ARCHITECTURAL REVIEW COMMISSION AGENDA

May 30, 2019

To: CH Architectural Review Commission (ARC)
From: Matt Taylor, Senior Planner
Date: May 30, 2019
Subject: Canyons Veterinary Clinic: Project SPL-19-006

To: Architectural Review Commission
From: Andy Hulka, Associate Planner
Date: May 30, 2019
Subject: SPL-19-003 – 6890 S. Highland Dr. – KFC

Front Elevation (East)

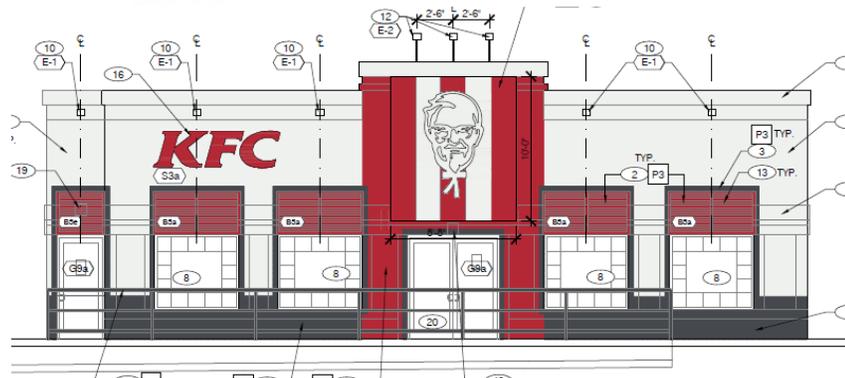
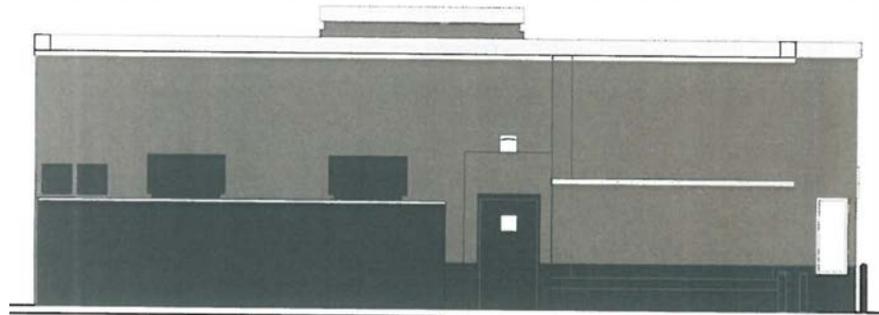
The March 2019 ARC approval required the signage above the entrance to encompass the doors and continue to the base as a single element. The revised plans have retained the half panel entry sign but have painted the entryway red to match the color of the sign. The applicant sent the following explanation for their inability to meet the ARC's initial condition of approval:

"We cannot conform to the architectural review attached which requests we put a full panel at this location. The full panel would cover our ADA entrance which is not in compliance with ADA standards. We cannot put any panels down the sides of the doors as this would not be approved under the National branding standards of KFC. Please find attached picture of a

Rear Elevation (West)

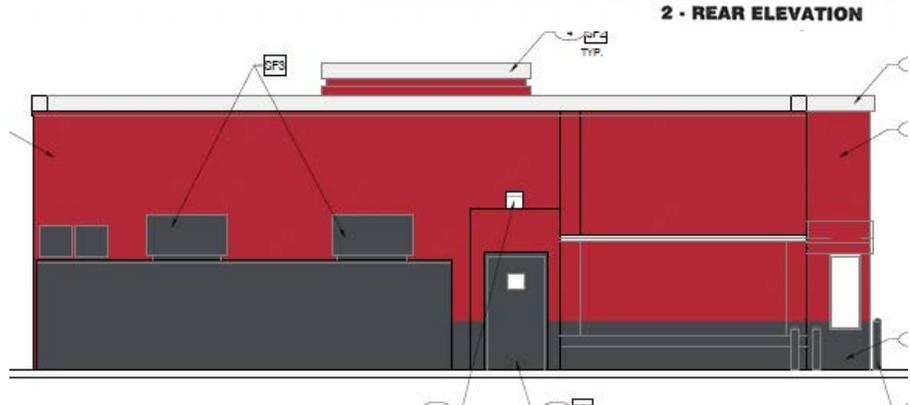
The west wall is now proposed to be painted almost entirely red.
